Bulletin No.: 20760

PRODUCT SAFETY RECALI

Brake Pedal Pivot Nut/Bolt Loose

2015 - 2016 Chevrolet Silverado HD

4404307

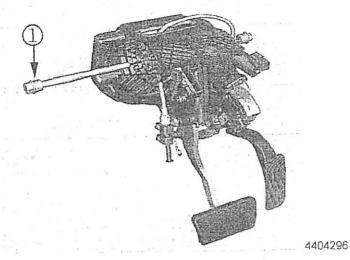
Using an inspection mirror, determine if the brake pedal pivot nut is on the outboard side of the vehicle.

• If the brake pedal pivot nut (1) is on the outboard side of the vehicle, proceed to step 2.

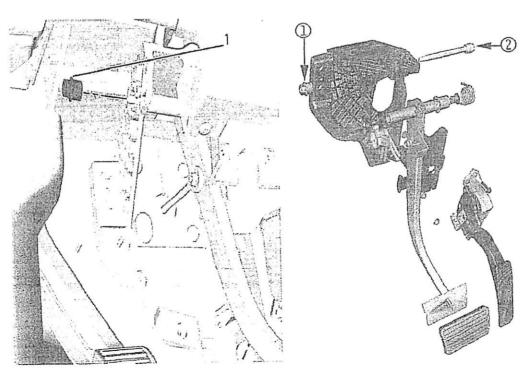
- If the brake pedal pivot bolt (1) is on the outboard side of the vehicle (nut on the inboard side), no further action is required.
- 2. Remove the Instrument Panel Knee Bolster. Refer to Instrument Panel Knee Bolster Replacement in SI.
- 3. Remove the Floor Front Air Outlet Duct Replacement Left Side. Refer to Floor Front Air Outlet Duct Replacement Left Side in SI.

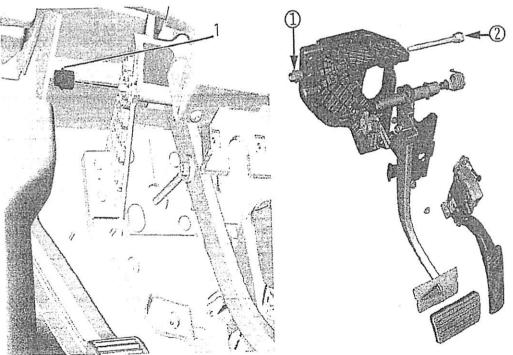
Note: Do NOT get threadlocker on the exterior of the brake pedal pivot nut. The exterior of the brake pedal pivot nut must be kept clean of threadlocker.

Holding the nut horizontally, apply two drops of red threadlocker to the threads in the collar portion (1) of the nut.
